AQUIND INTERCONNECTOR

Design and Access Statement

Document Ref: 5.5

DATE: 23 DECEMBER 2020

Plate 4.3 – Vertically arranged green cladding

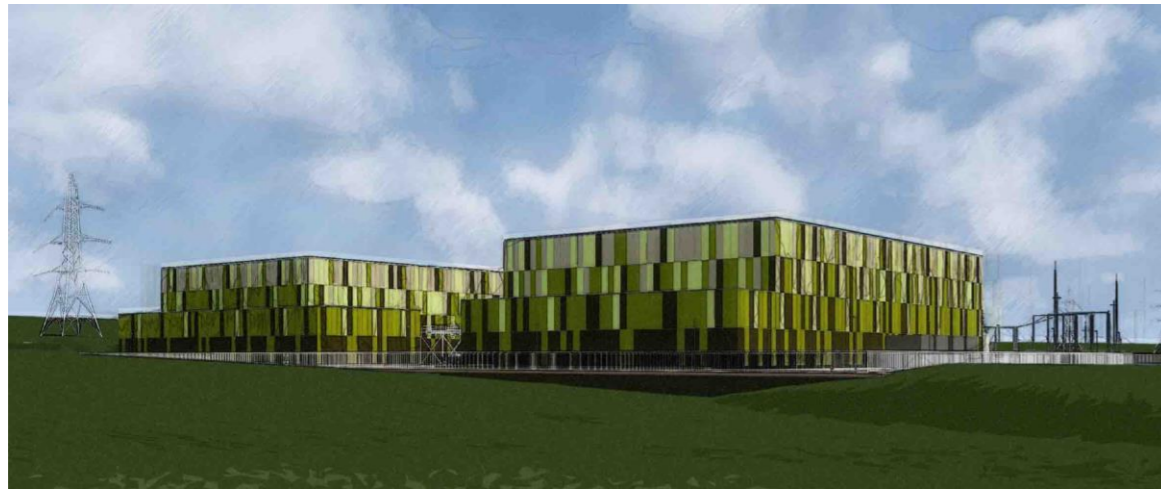
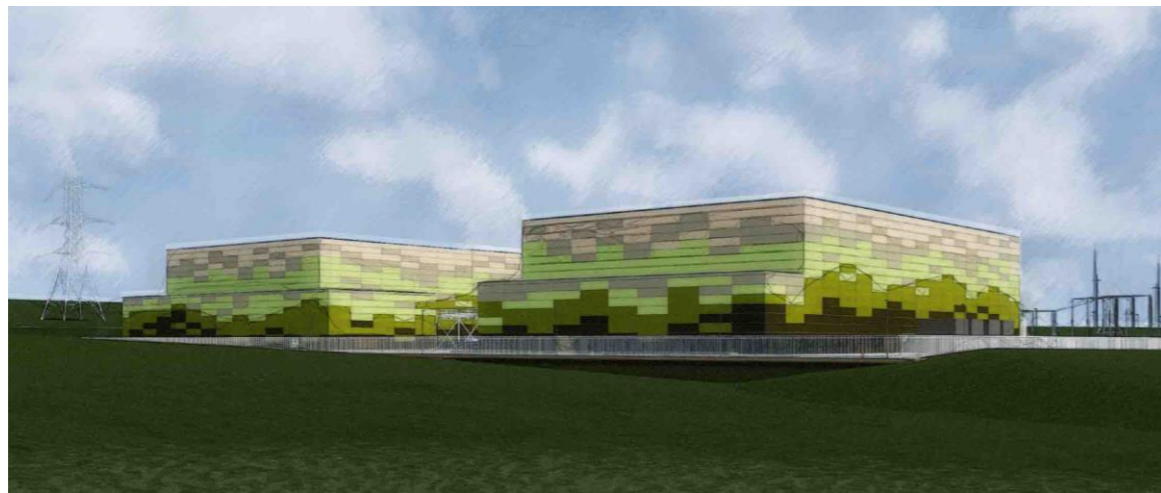
4.3.3.2. The site constraints were highlighted and discussed and three design options were explained in more detail. Options one and two both used rich green cladding arranged vertically and horizontally in order to blend into the landscape, with the third option being a darker option with a stronger architectural character. The first two options therefore sought to soften the building while the third option sought to celebrate the building. (Plates 4.3; 4.4 & 4.5)

- **Comment:** Should the building be concealed or celebrated?
- **Response:** This was a concept that was proposed by EHDC, but other attendees expressed a preference for concealment. The alternatives were debated and it was agreed that prominent curved roofs (Plate 4.1) would be discounted.

Plate 4.7 – Design options presented

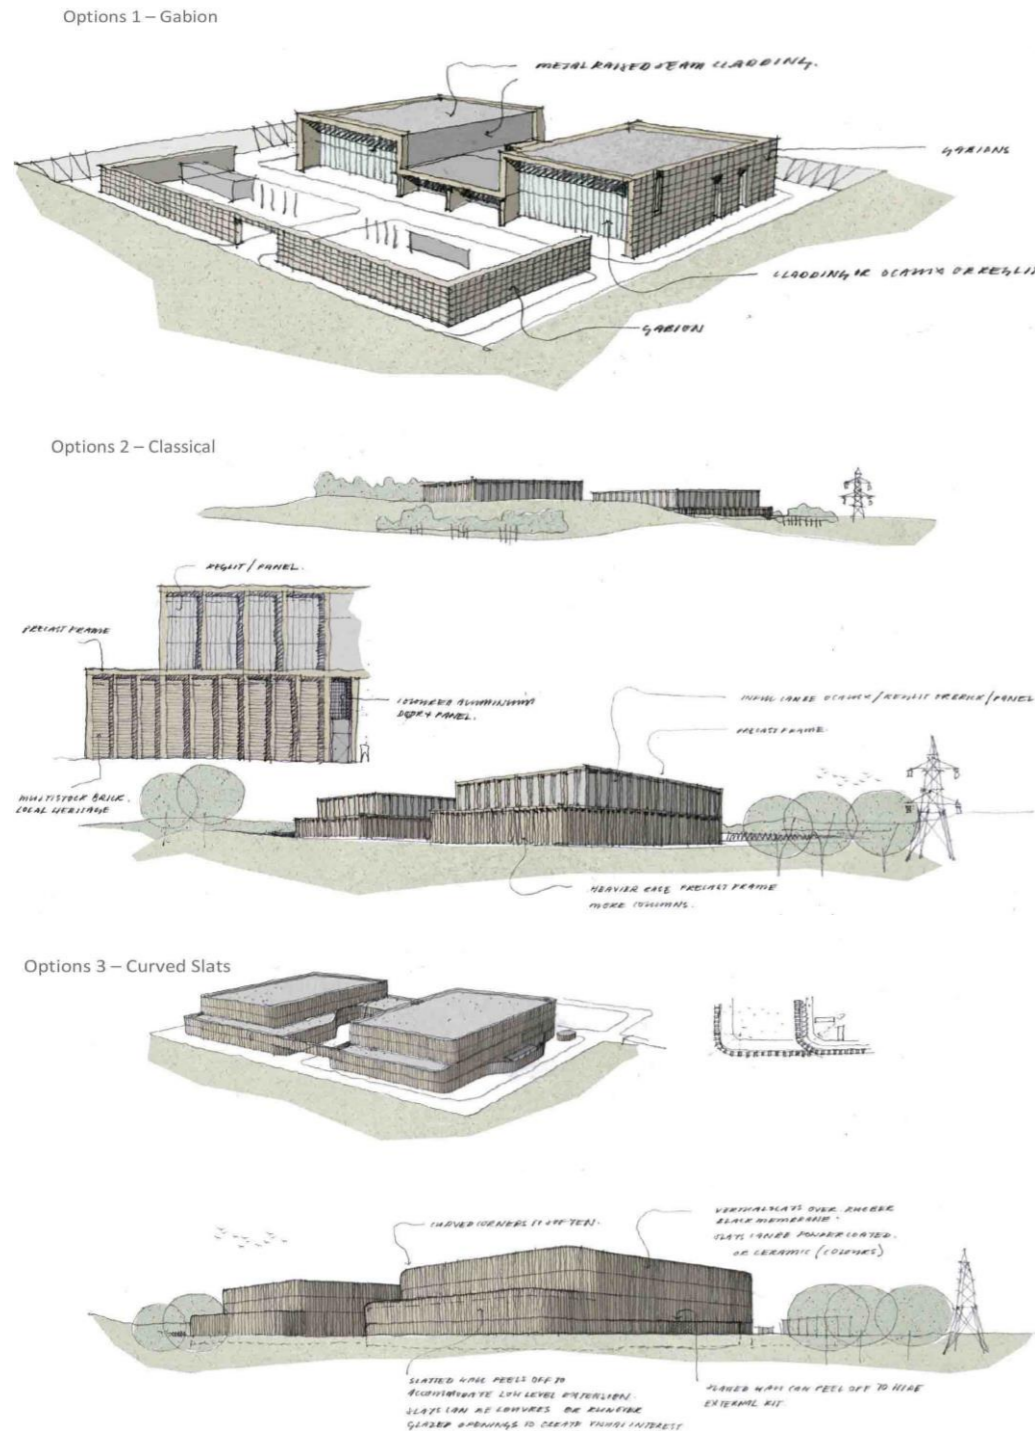
4.3.5.1. The first Converter Station Design Meeting post the statutory consultation stage. The known site constraints were tabled (refer to Plate 4.6) to explain the limitations that influence where and what landscape mitigation can occur. Building upon this, the built form responses to the consultation were presented and explained (refer to Plate 4.7 below)

Plate 4.11– “Summer Greens” option.

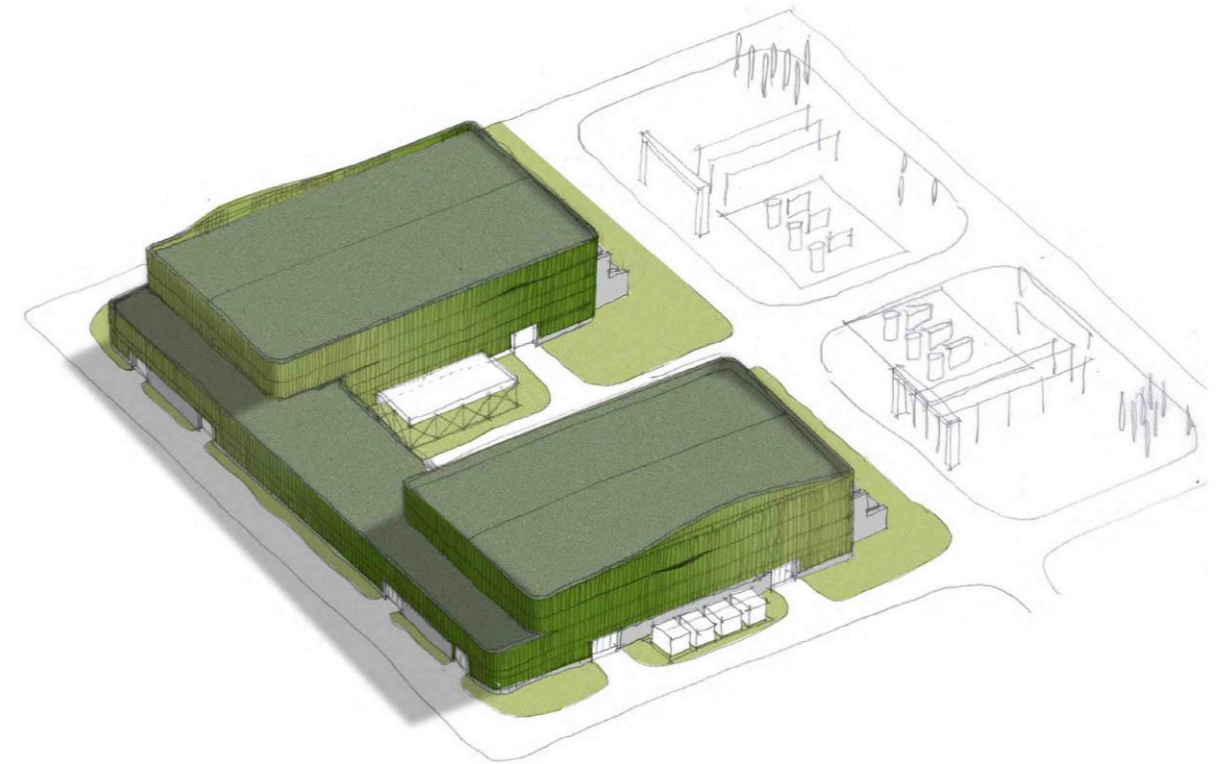
- **Comment:** (WCC) Request to explore a distinctive plinth element.
- **Response:** It was agreed to consider in further detailed design development
- **Comment:** (WCC and SDNPA) Agreement to discount the “summer greens” colour palette (refer to Plate 4.11).

- **Response:** Preference noted.
- **Comment:** (WCC) Request to ensure horizontal banding is included.
- **Response:** Agreed to retain and emphasise.
- **Comment:** (WCC and SDNPA) Concern expressed that “wave” forms to roof (refer to Plate 4.11) would have little impact when viewed from a distance.

- **Response:** Agreed to omit.
- **Comment:** (WCC) Request to consider blue/grey/brown colours.
- **Response:** Colour palettes to be investigated further for next meeting.
